©Kawasaki Motors Corp 1974 Printed in USA

PROBLEM:

The H2 750cc engine can loosen in its frame mounting, causing rider discomfort and accelerated wear. In an extreme case, the frame lugs may fracture from engine vibration, aggravated by the loose mounts.

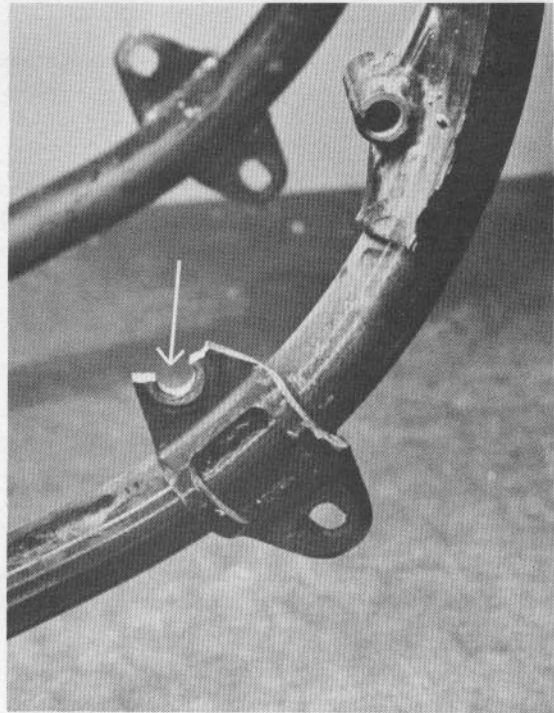
The frame lugs have 1.0-1.5mm clearance with the engine mounting bosses to allow easy removal/installation. These lugs are meant to be pulled in as the bolts are tightened. It has been found that the lugs take a "set", relieving tension on the mounting bolts.

Engine mount shims must be used to take up the clearance between the frame lugs and engine bosses at the two bottom mounts. The factory has installed these shims on all H2's after Frame No. H2F-09082.

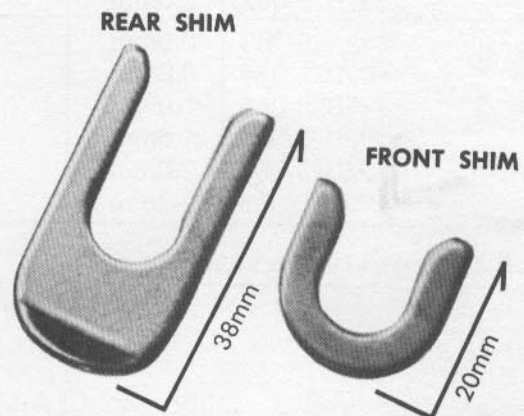
IMPORTANT:

For all units before frame number H2-09082, the shims *must* be installed.

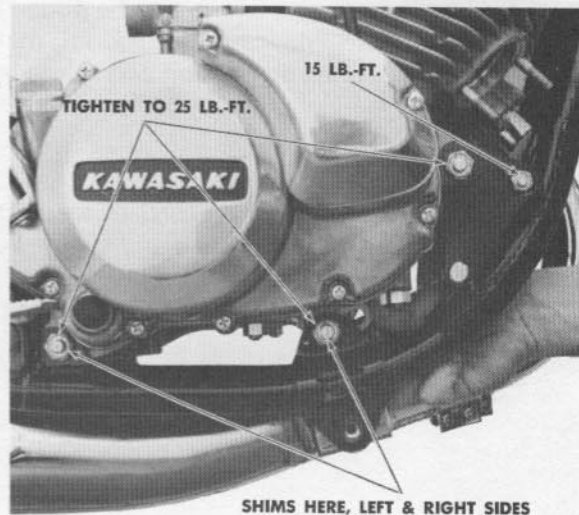
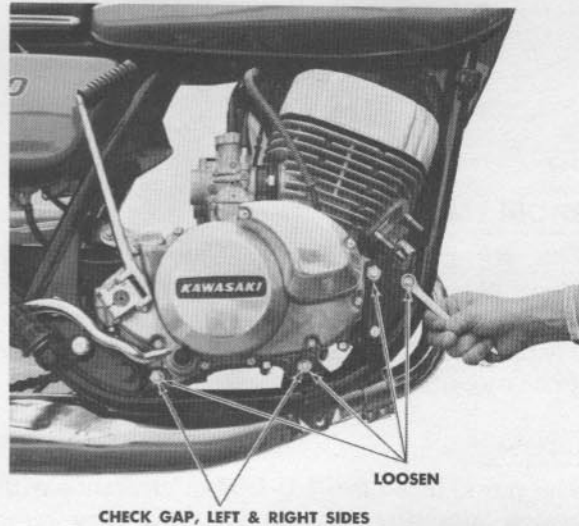
INSTALLATION:

- A. Take off the left and right mufflers, and loosen the center exhaust pipe holder nuts. **IMPORTANT:** This step relieves the front mounting lugs of outside stresses which could affect shim adjustment. Loosen the engine mount bolts shown here.
- B. Without moving the engine, use feeler gauges to check the clearances between the engine bosses and frame lugs at these 2 mounts (both sides).
- C. At each of the 4 gaps, insert the correct-sized shim to take up all clearance. **NOTE:** *If necessary, you can "stack" the shims.*
- D. Tighten the three 10mm \emptyset engine mount bolts to 25 lb.-ft. torque. Then tighten the 8mm \emptyset bolt with 15 lb.-ft. torque.
